ADDENDUM NO. 2

Date: August 18, 2014

Project: City of Tuscaloosa
City Walk at University Place and Forest Lake
Project No. A12-1413/A12-0993

STREET / PEDESTRIAN LIGHT POLE ASSEMBLY

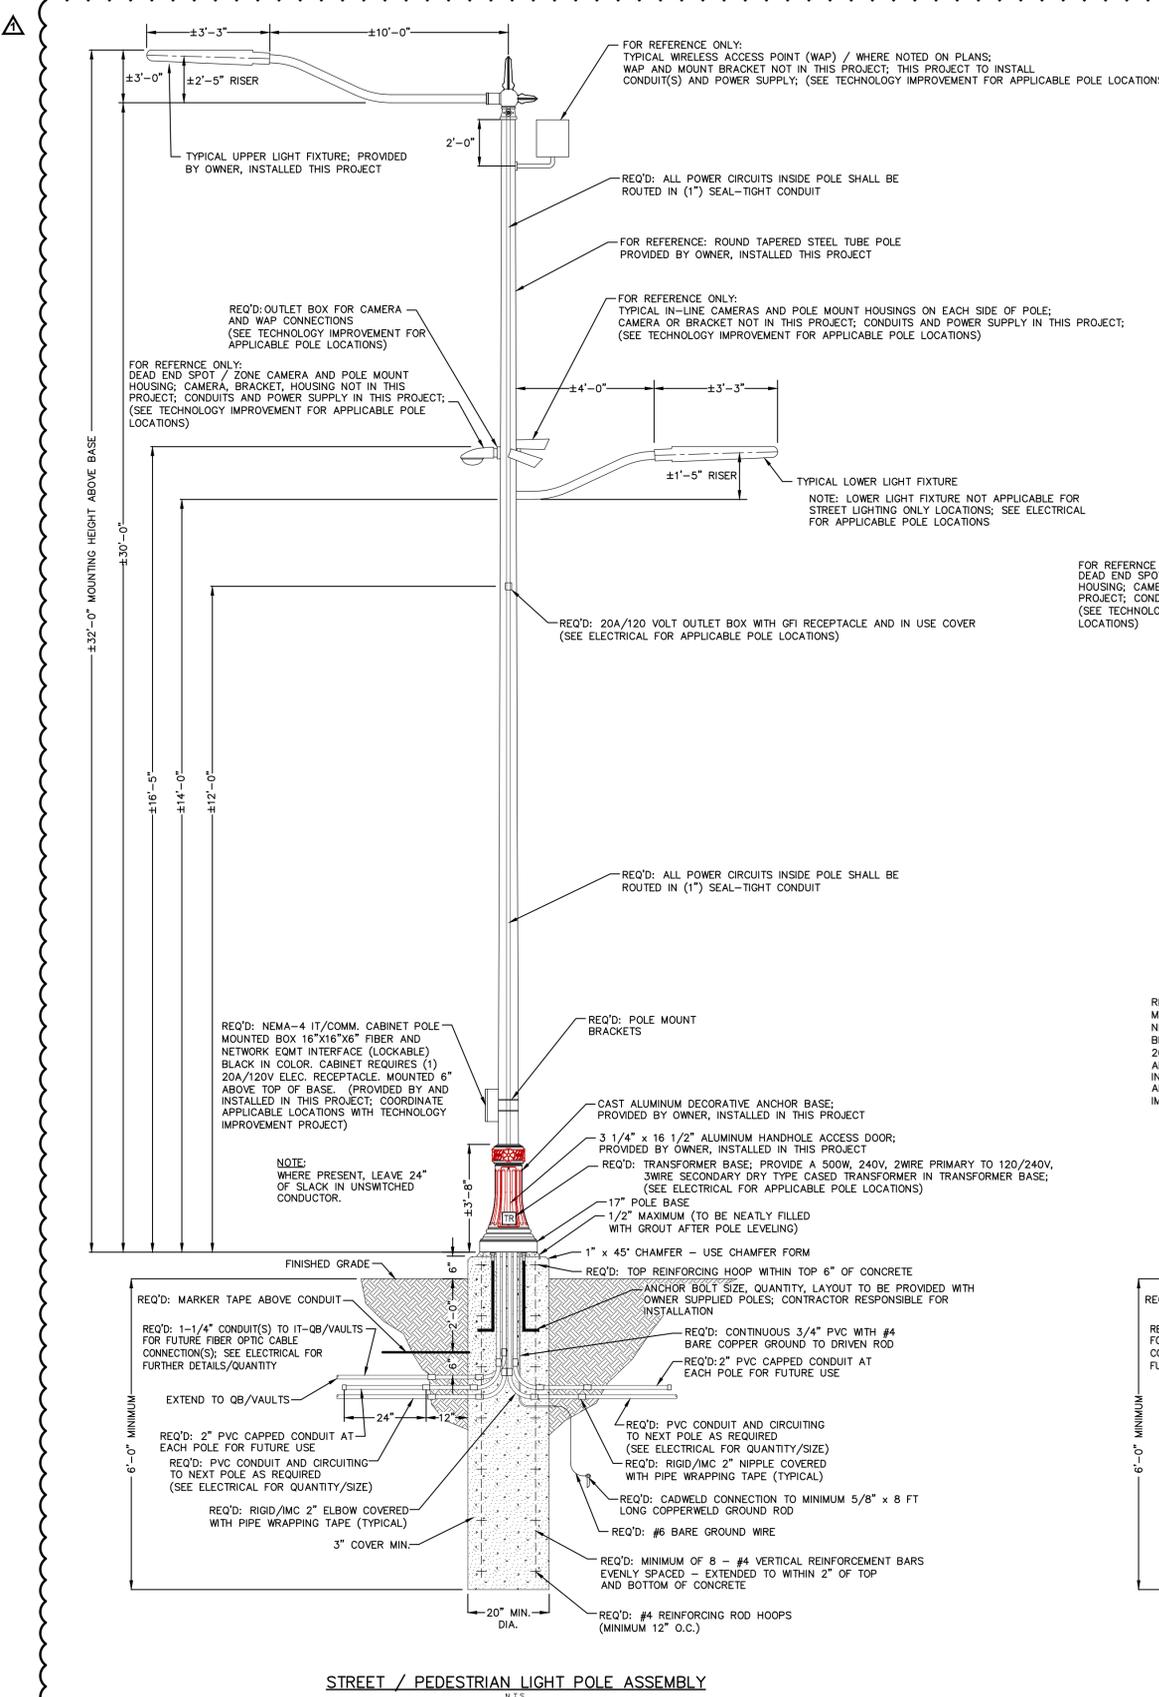
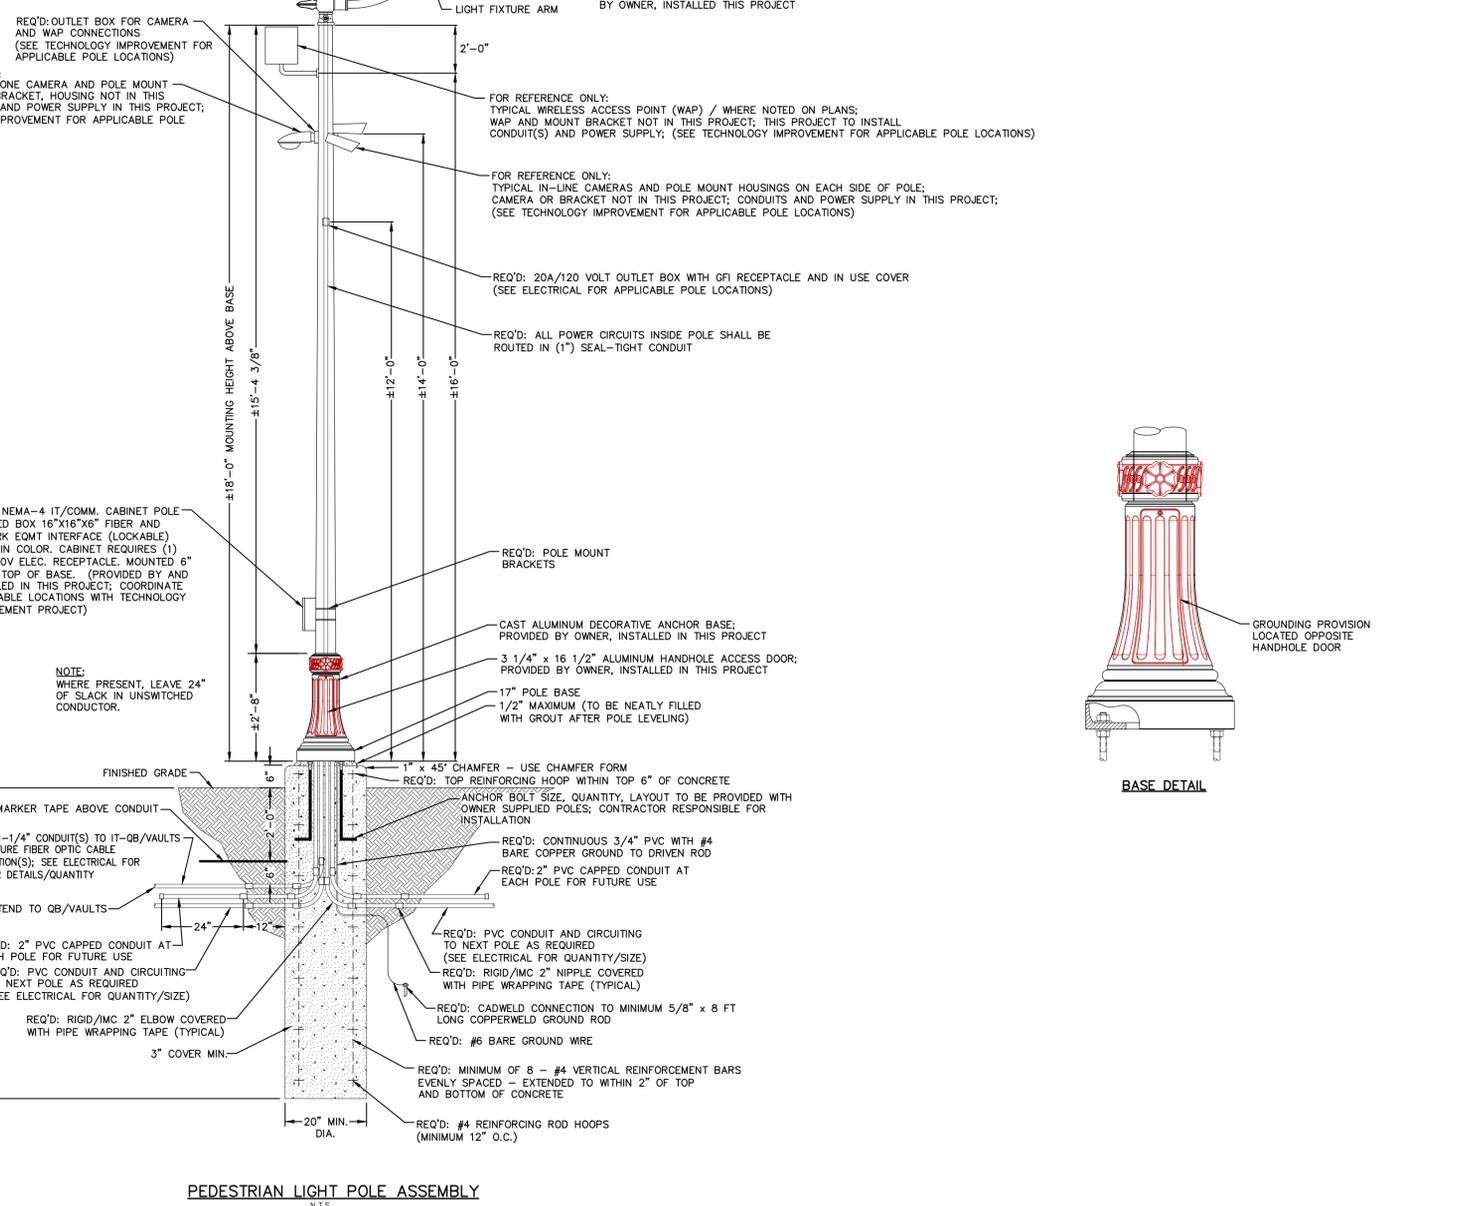
- c) Sheet C8.4 – elimination of duplicate ALPCO pull box details and duct bank trench revisions
 - d) Sheet C8.5 – modification of pole details
 - e) Sheet C8.9 – general modification of ALPCO details

INLET PROTECTION CONSTRUCTION STAGES NOTES:

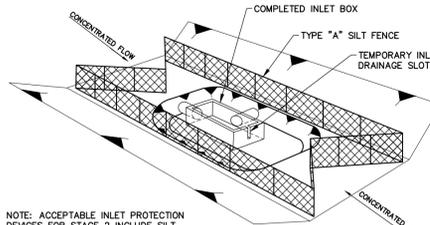
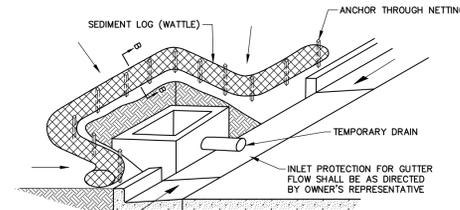
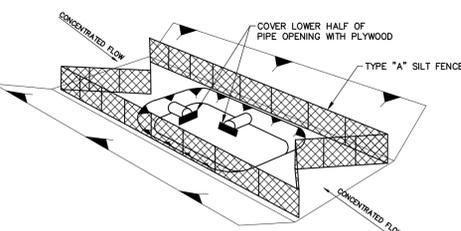
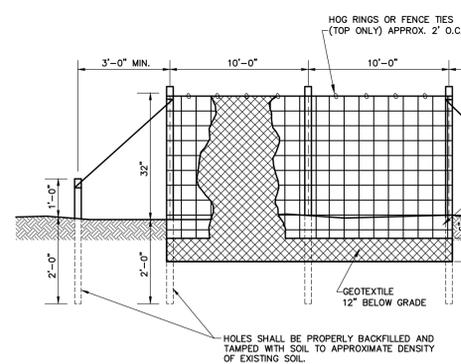
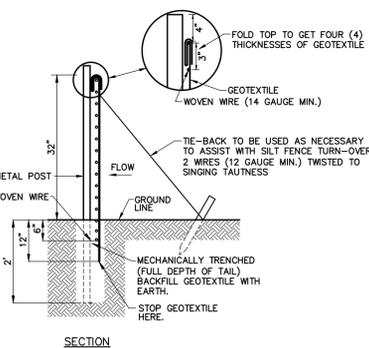
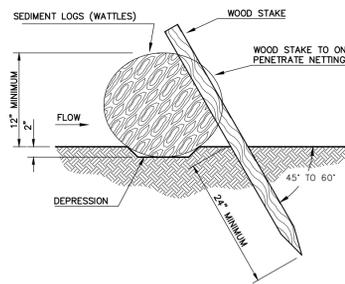
5. **Construction Plans:**
 - a) Sheet C2.0 – demolition of existing light pole assembly
 - b) Sheets C5.0, C5.1, and C8.7 – general revisions to erosion control plans (C5.0 and C5.1) and erosion/sedimentation control details (C8.7)
